GEORGIA POWER COMPANY
OGLETHORPE POWER CORPORATION
MUNICIPAL ELECTRIC AUTHORITY OF GEORGIA
CITY OF DALTON, GEORGIA
DOCKET NO. 50-321
EDWIN I. HATCH NUCLEAR PLANT, UNIT NO. 1
AMENDMENT TO FACILITY OPERATING LICENSE

Amendment No. 151
License No. DPR-57

ATTACHMENT TO LICENSE AMENDMENT NO. 151

Amendment No. 89
License No. NPF-5

FIGURE 3.2.1-2

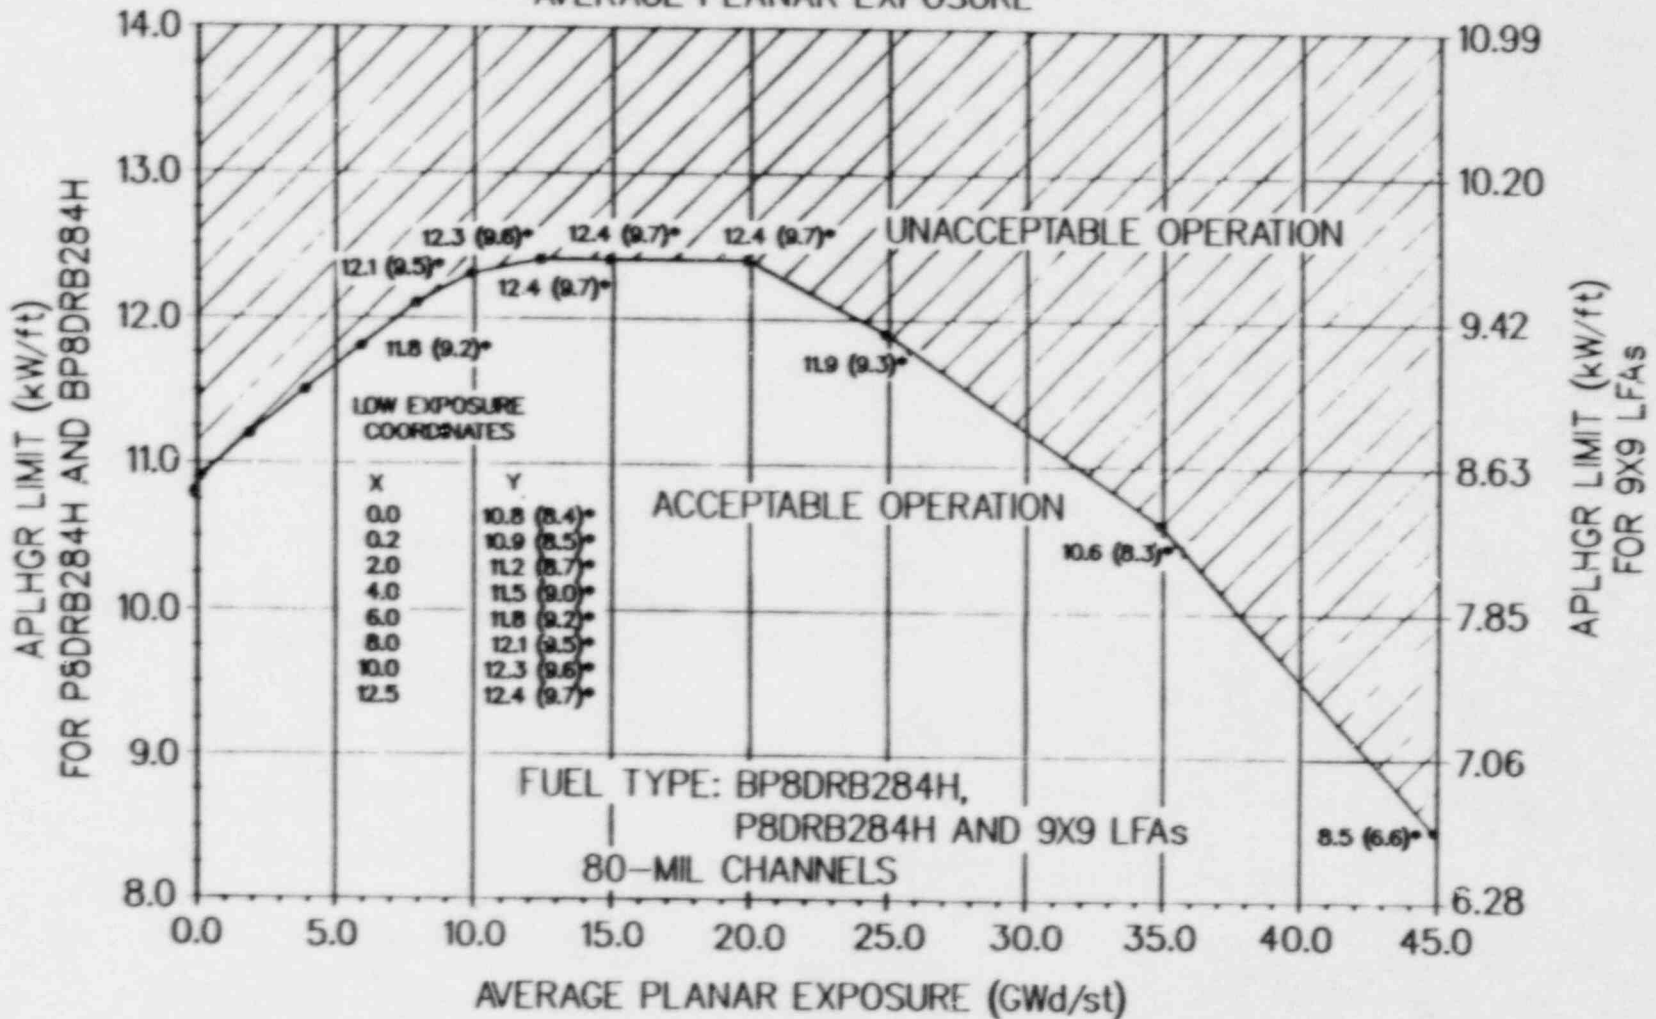
For convenience, the APLHGR limits are reported in the units of kW/ft, which is the bundle planar power normalized to the number of fueled rods. Figure 3.2.1-2 shows that the 9x9 LFAs have the same planar power limits as the GE P8DRB284H fuel; however, on a kW/ft basis, the APLHGR limits for the LFAs are 62/79 times the P8DRB284H limits.

ALL 8 X 8R AND 9 X 9 LFA FUEL TYPES
FIGURE 3.2.3-1

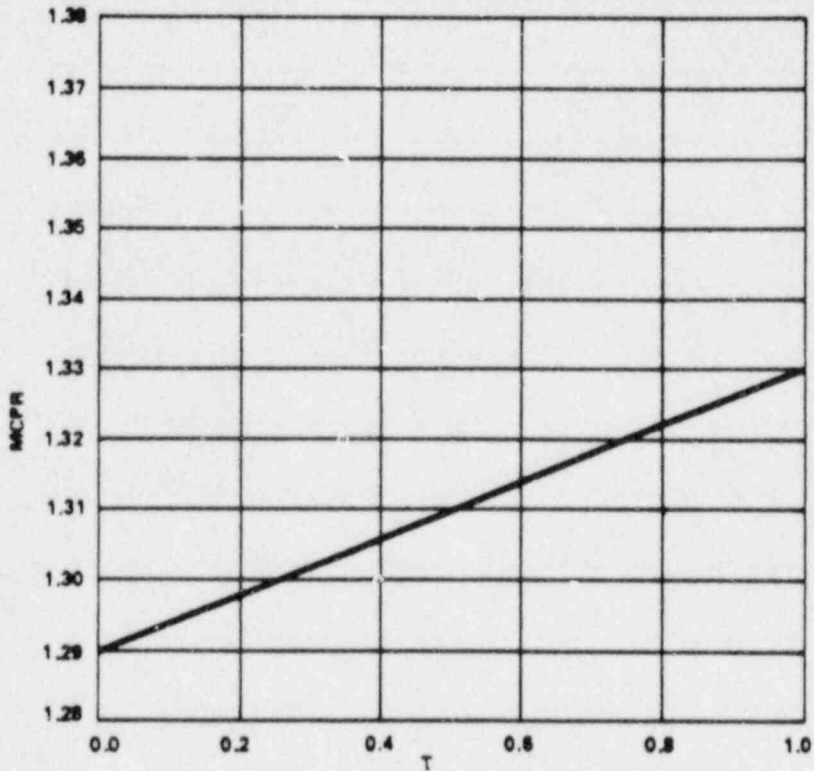
4.2.3 The MCPR limit at rated flow and rated power shall be determined for each type of fuel (8X8R, P8X8R, BP8X8R, 9X9 LFA, and 7X7) from Figures 3.2.3-1 and 3.2.3-2, using:
